# UNITED STATES PATENT AND TRADEMARK OFFICE

APPLICATION NO.	FILING DATE	FIRST NAMED INVENTOR	ATTORNEY DOCKET NO.	CONFIRMATION NO.
10/632,545	08/01/2003	Michael F. Brletich	12539	2681

<b>Office Action Summary</b>	<b>Application No.</b> 10/632,545	<b>Applicant(s)</b> BRLETICH ET AL.	
	<b>Examiner</b> Ernesto Garcia	<b>Art Unit</b> 3679

FIG. 35

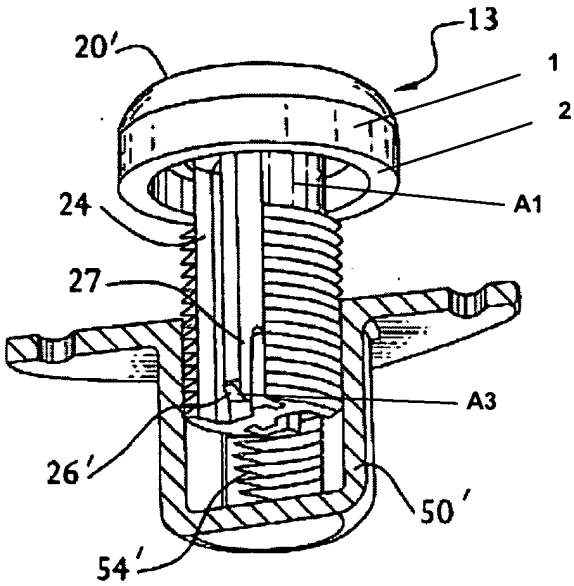
Regarding claim 1, Antonucci et al. disclose, in Fig. 35, a device comprising a fastener plug **13** including a plug portion **20'** and a fastener portion **24**. The plug portion **20'** defines an end cap **20'** and at least one disc **28** spaced apart from the end cap **20'**. The fastener portion **24** defines a flexible extension member **27** extending outwardly from the end cap **20'** and across the at least one disc **28**. The extension member **27** includes a projecting member **26'**. Given the structure of Antonucci et al. above, the disc is sized and shaped to mate with and seal an open end of a bar. The flexible extension member is able to flex as the member is installed in the open end of the bar and snap back to an original position when the projection member engages an aperture in a sidewall of the bar. Further, the disc defines a diameter slightly larger than a diameter of the open end of the bar, and the projection member can be adapted for operatively engaging the aperture in the sidewall of the bar.

Regarding claim 2, the end cap **20'** defines a peripheral edge **B1** (see marked-up attachment) and a flat surface edge **B2** along the peripheral edge **B1**. Note, the claims are written with a broad breadth that Antonucci et al. reads on this claim. Applicants should consider rephrasing that the peripheral edge has a truncated edge or truncated surface.

Regarding claim 3, a rib **A1** connects the disc **28** to the end cap **20'** (see marked-up attachment provided in the Office action mailed on 7/14/2005).

Regarding claim 4, the disc **28** is a plurality of discs **28** spaced apart from the end cap **20'**.

Regarding claim 5, the extension member **27** extends upwardly from the end cap **20'**.

Regarding claim 6, the extension member **27** extends across the discs **28**.

Regarding claim 7, the discs **28** define a flat surface edge **A2**.

Regarding claim 8, the projection member **26'** defines an inclined surface **A3**.

Regarding claim 15, Antonucci et al. disclose, in Figure 35, a device comprising a fastener plug **13**. The fastener plug **13** includes an end cap **20'** and discs **28** spaced apart and connected to the end cap **20'** by at least one rib **C1** (see marked-up attachment). The end cap **20'** defines a peripheral edge **B1** and a flat surface edge **B2** along the peripheral edge **B1**. The fastener plug **13** includes an extension member **27** extending outwardly from the end cap **20'** and across the discs **28**. The extension member has a fixed end connected to the end cap **20'** and a free end opposite the fixed end. The free end includes an aperture engaging-member **26'**.

FIG. 3

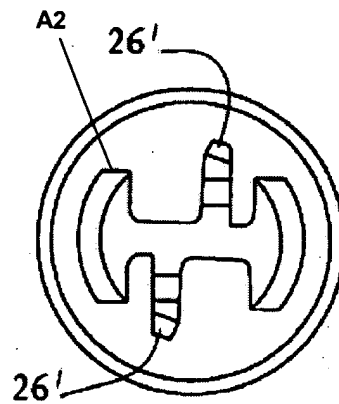
Regarding claim 21, Rabinovitz discloses, in Fig. 1, a device comprising a plug **220** including an end cap **226** and a body **A1** (see attachment of Figure 3 for reference) extending from the end cap **226**. The end cap **226** includes a peripheral edge **A2** and a flat truncated surface **A3** along the peripheral edge **A2**. The plug further includes only one flexible extension member **A4** having an end fixed **A5** to the plug **220** and a free end **A6** opposite the fixed end **A5**. The flexible extension member **A4** includes at least a portion thereof extending between and with a space defined by the end cap **226** and a portion of the body that is spaced farthest from the end cap **226**. The free end **A6** includes **A6** an aperture-engaging member **222**. The plug **220** includes a portion **A7** on a side thereof directly opposite the flexible extension member **A4**.
